**HISTORIC AND DESIGN REVIEW COMMISSION
COMPLIANCE AND TECHNICAL ADVISORY BOARD**

HDRC CASE NO: 2024-131
ADDRESS: 302 LAVACA ST
LEGAL DESCRIPTION: NCB 714 BLK 11 LOT 9 & 10
ZONING: RM-4, H
CITY COUNCIL DIST.: 1
DISTRICT: Lavaca Historic District
APPLICANT: Diane Holden Jones /QC JONES INVESTMENTS LLC
OWNER: Diane Holden Jones /QC JONES INVESTMENTS LLC
TYPE OF WORK: Door replacement
APPLICATION RECEIVED: March 12, 2024
60-DAY REVIEW: May 11, 2024
CASE MANAGER: Claudia Espinosa

The applicant is requesting a Certificate of Appropriateness for approval to replace the existing front door and sidelites configuration with a wood door in place of the current configuration.

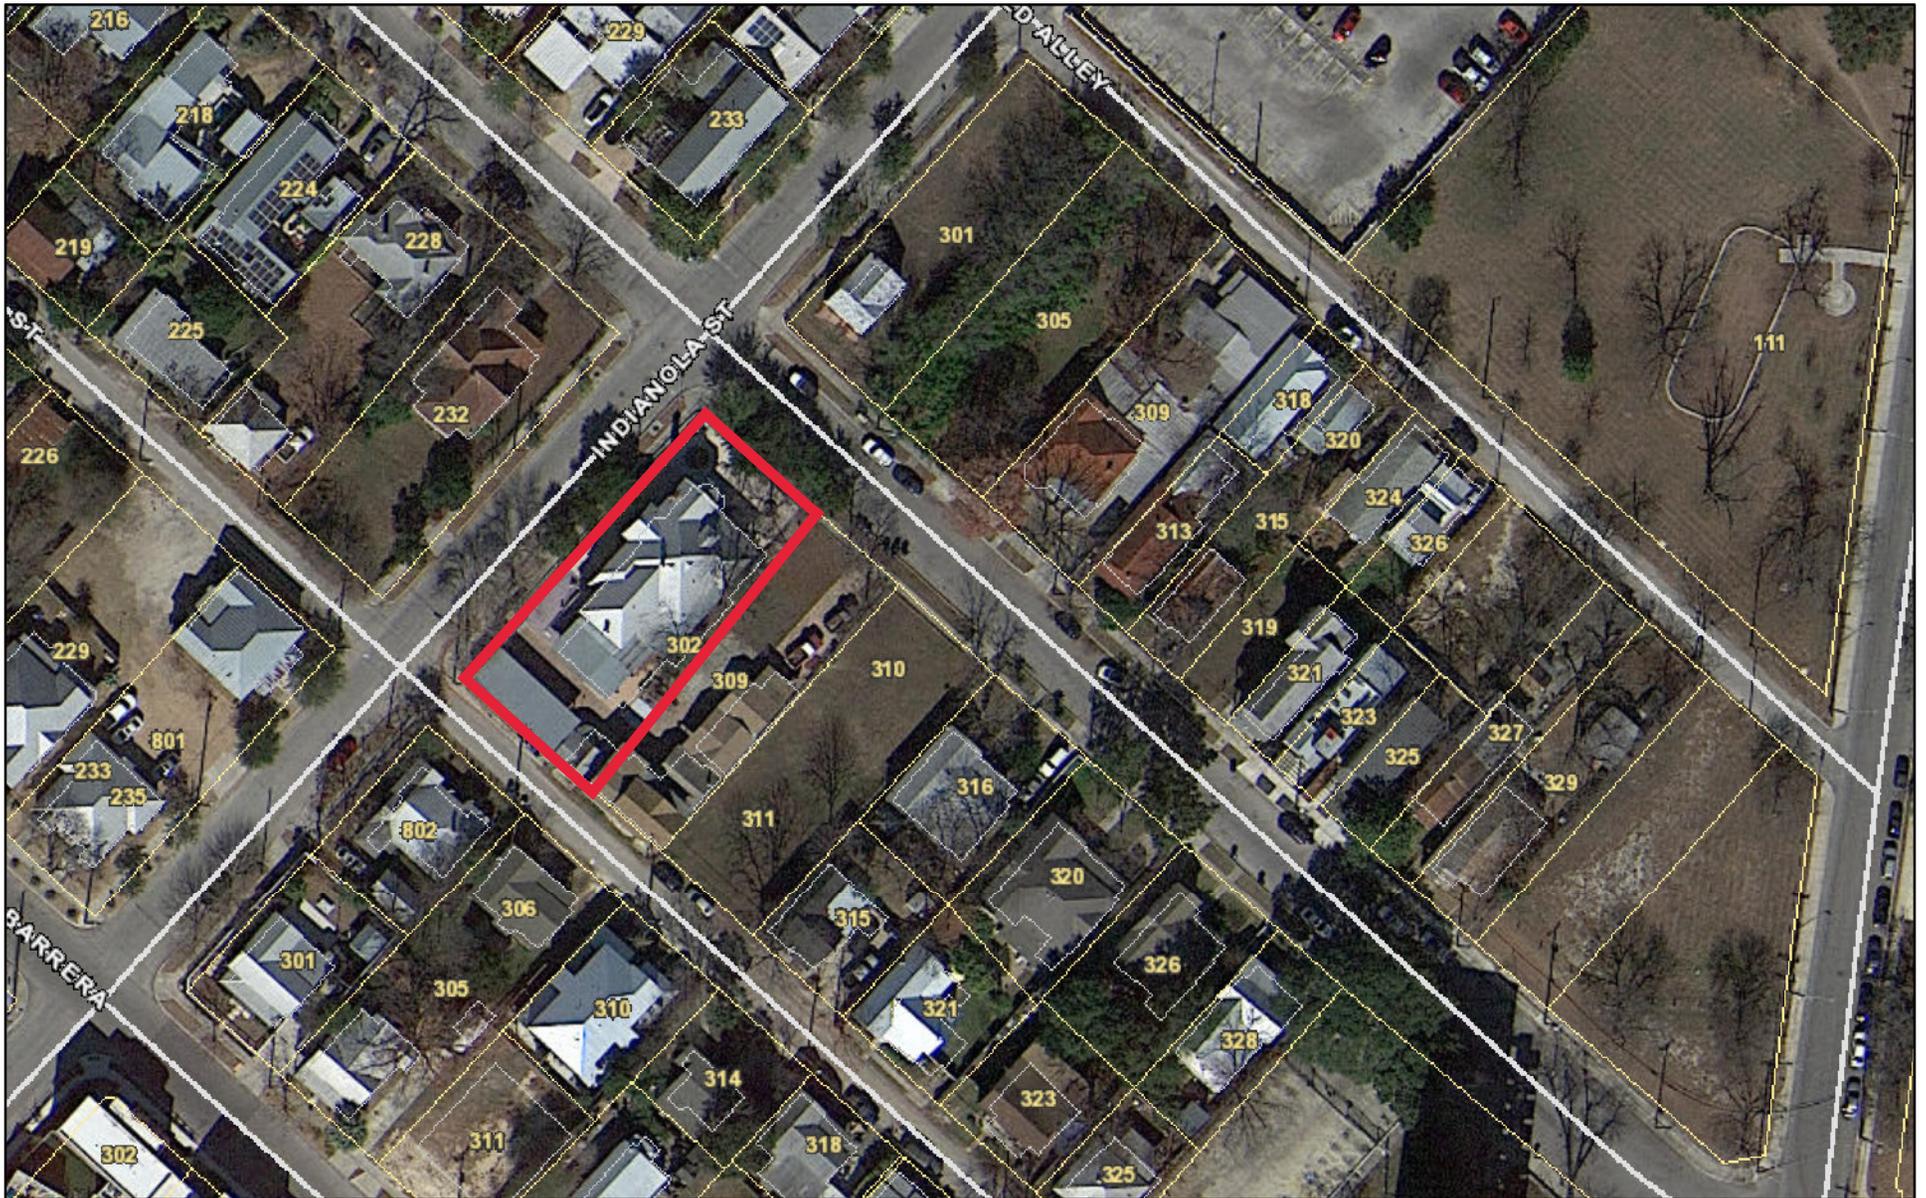
b. FRONT DOOR INSTALLATION – The applicant has proposed to remove the existing sidelite and front door configuration and install a wood door with a glass panel. Per the Guidelines for Exterior Maintenance and Alterations 6.A.i. original window and door openings should be preserved. Staff finds that, while the original materials have been replaced, the existing configuration with sidelites and transoms is likely original. The proposed removal of this configuration is not consistent with the Guidelines.

Staff does not recommend approval based on the finding b. A replacement door that fits within the existing opening is eligible for administrative approval.
